# **3. OPEN SPACE PLAN**

## **RESPONSE TO COMMENTS**

### R3.1 KENDALL SQUARE ROOFTOP GARDEN

R3.1 FIG. 1A

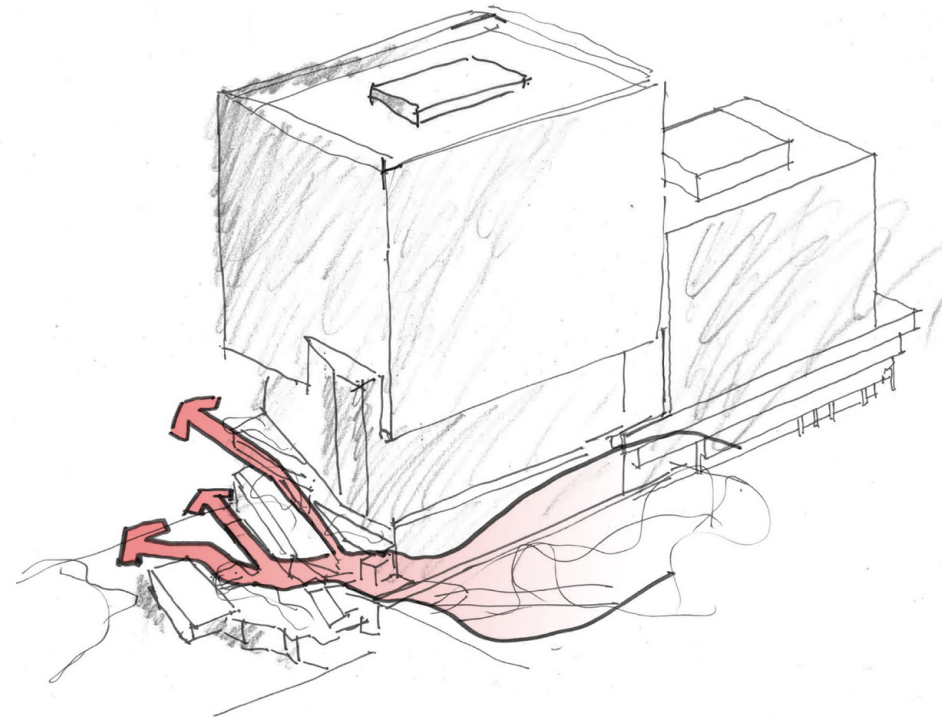
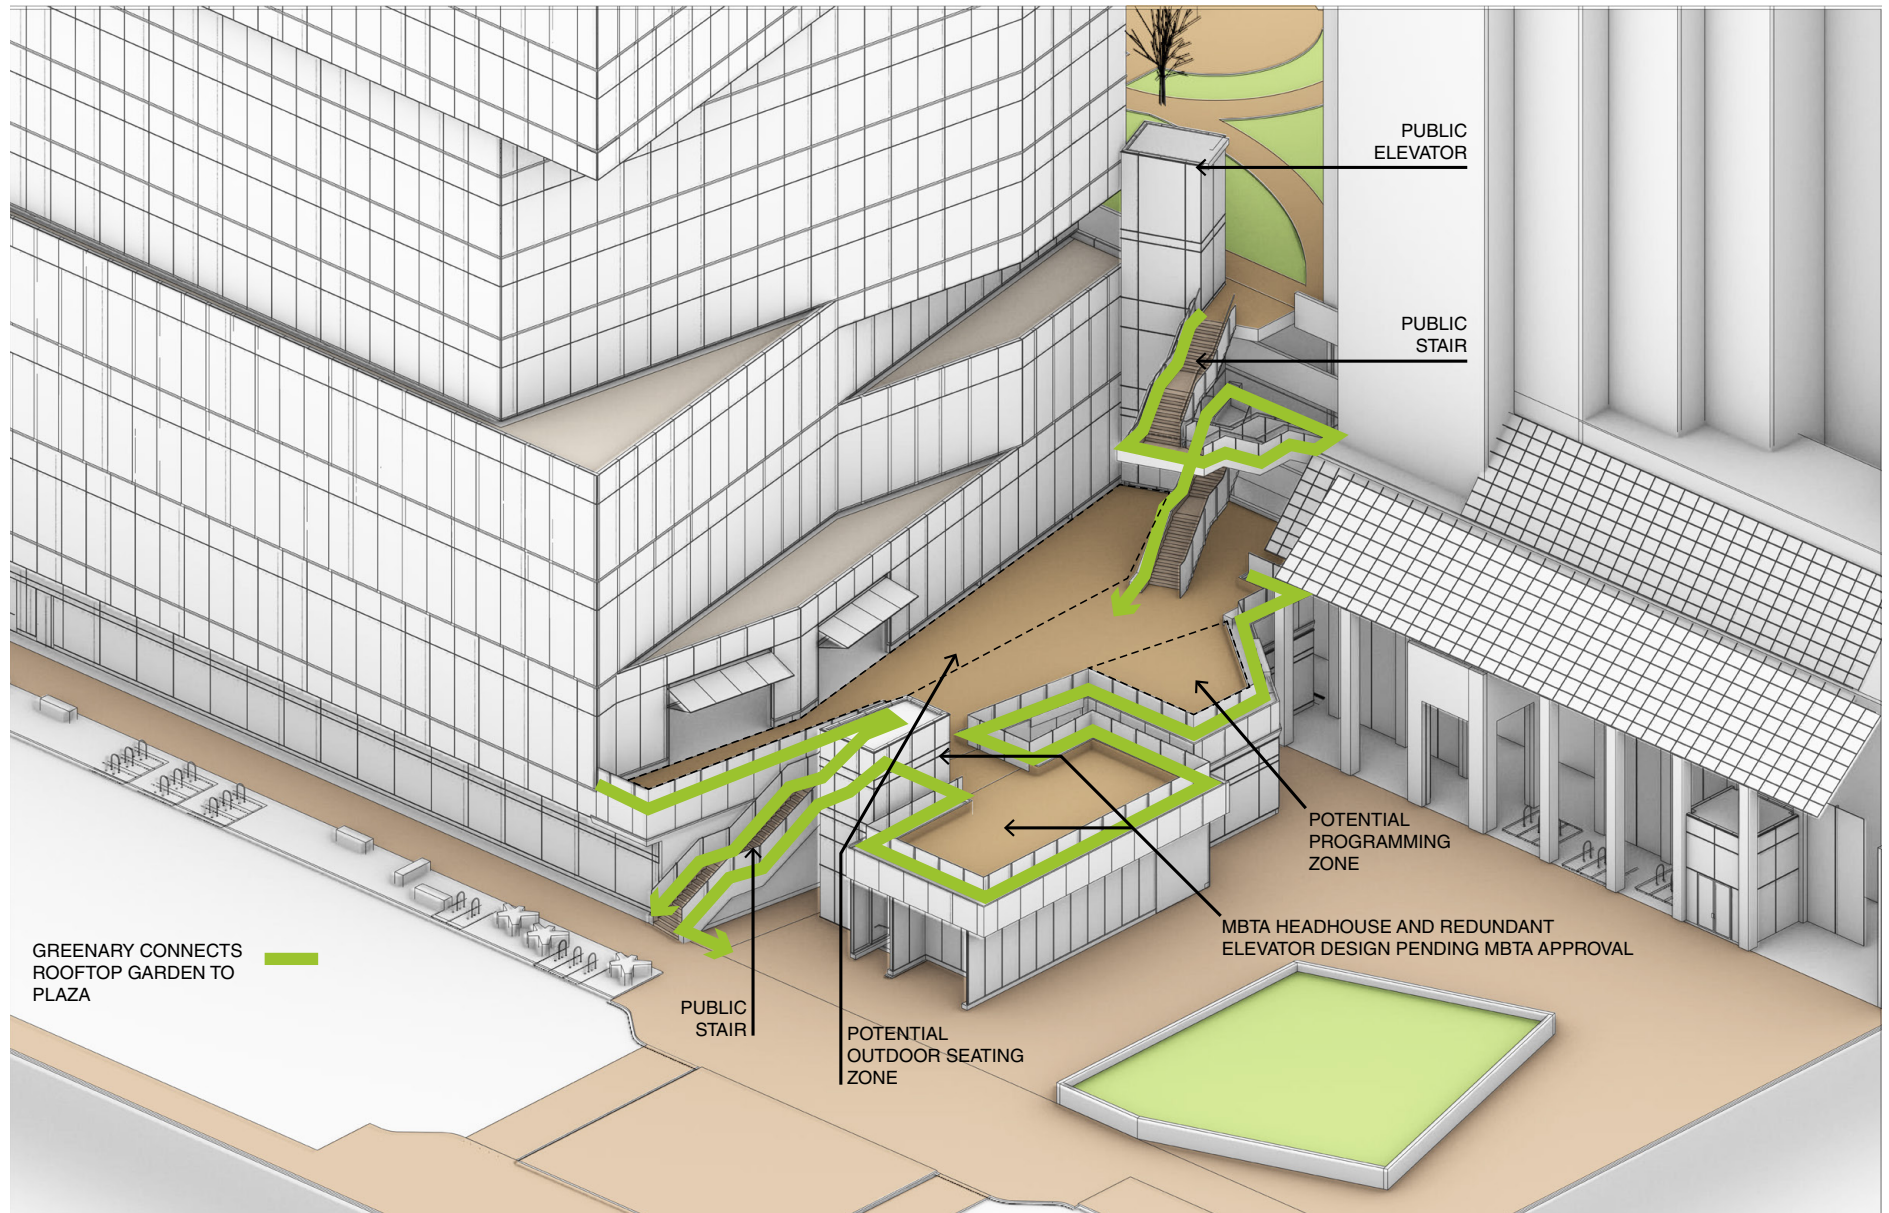
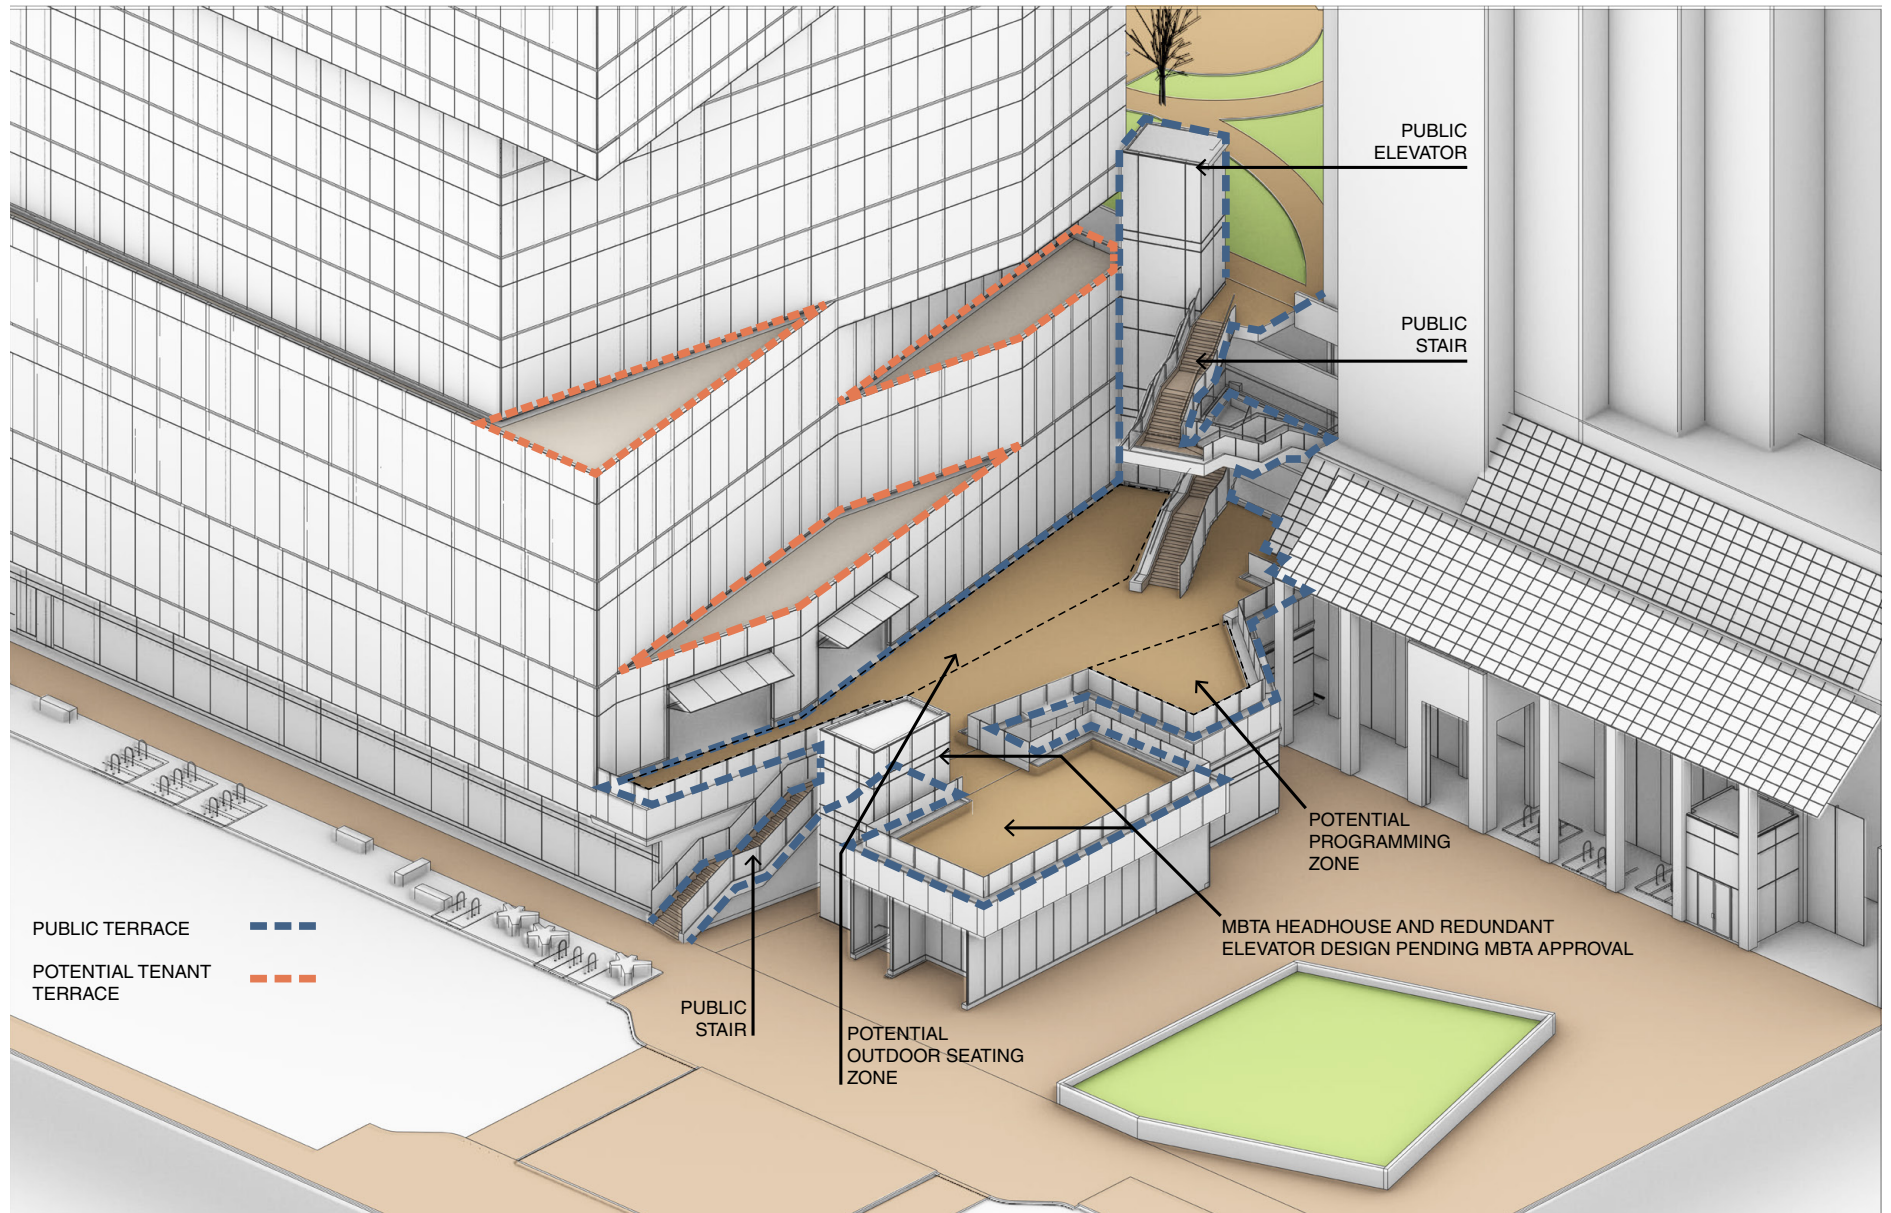
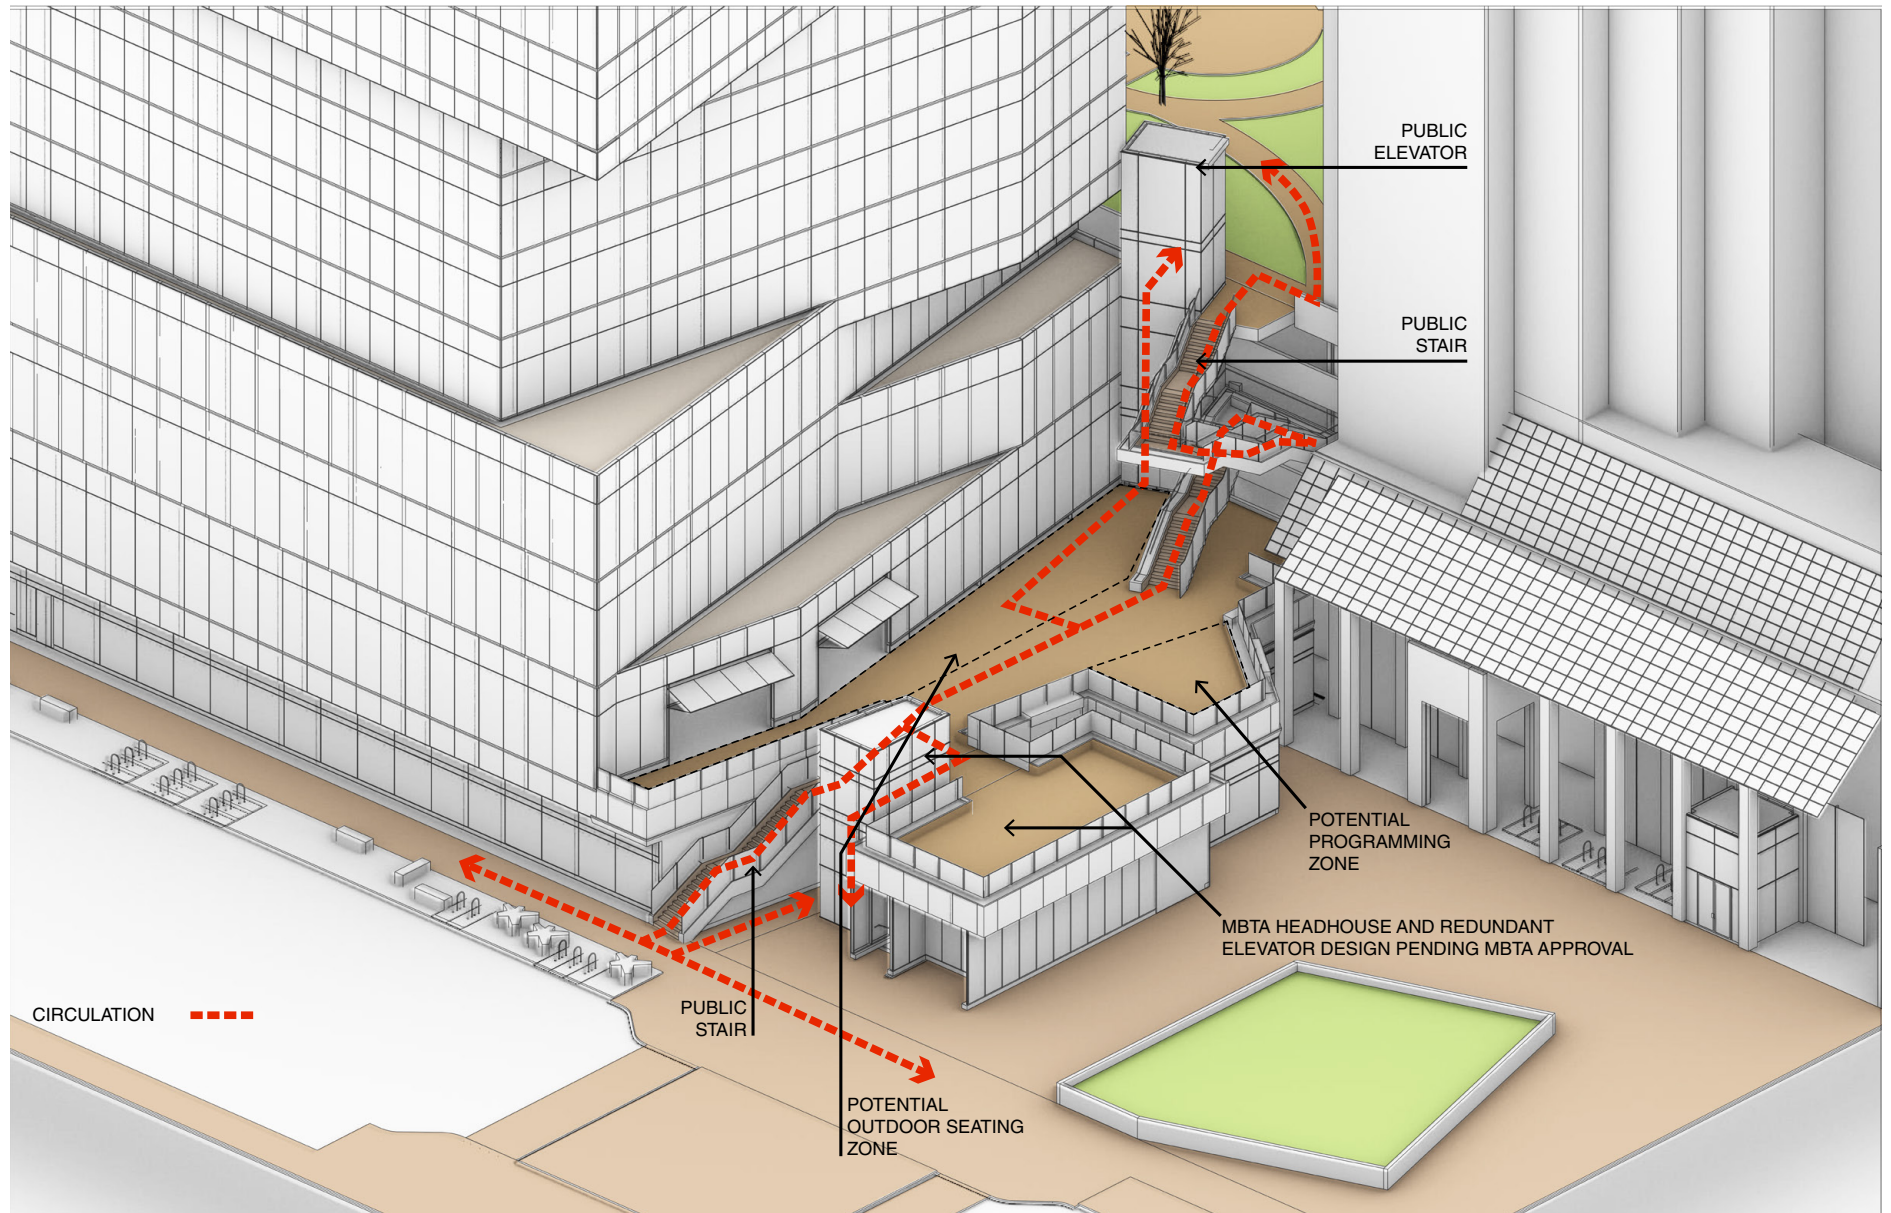
The Applicant received comments on the design of the proposed new connection between Kendall Plaza and the Kendall Square Rooftop Garden as well as the landscape design and future use of the Kendall Square Rooftop Garden. As presented at the Joint Board hearing on 10/2/18 and documented in the 325 Main Street Design Review Book submitted on 9/6/18, as part of this Concept Plan Amendment, a substantial terraced and landscaped connection is now proposed between the Kendall Plaza and the Kendall Square Rooftop Garden. As shown in R3.1 FIG. 1A, 1B, 1C, 1D, this connection provides highly visible stair and elevator public access between Main Street/Kendall Plaza, a new second level terrace, and the Kendall Square Rooftop Garden and is a significant new public benefit now associated with the Project. The design also offers additional opportunities for programming, supplementing the existing programming sponsored by the Applicant within Kendall Plaza and further reinforcing the Plaza's importance as the heart of activity within the Kendall Square district.

To create an even more engaging space and to promote additional public use of the Kendall Square Rooftop Garden during the warmer summer months, the Applicant proposes to extend its operating hours (currently from dawn to dusk) until 11:00 PM for the months of June to September. Additionally, as shown in R3.1 FIG. 14-21, extended public use of the Kendall Square Rooftop Garden will be further encouraged in two ways: (1) augmenting public programming and events with a variety of proposed activities available at different times of the day/week, such as lawn games and outdoor yoga classes, and (2) implementing a new lighting plan, allowing for the safe use of the Kendall Square Rooftop Garden during the extended summer evening hours.
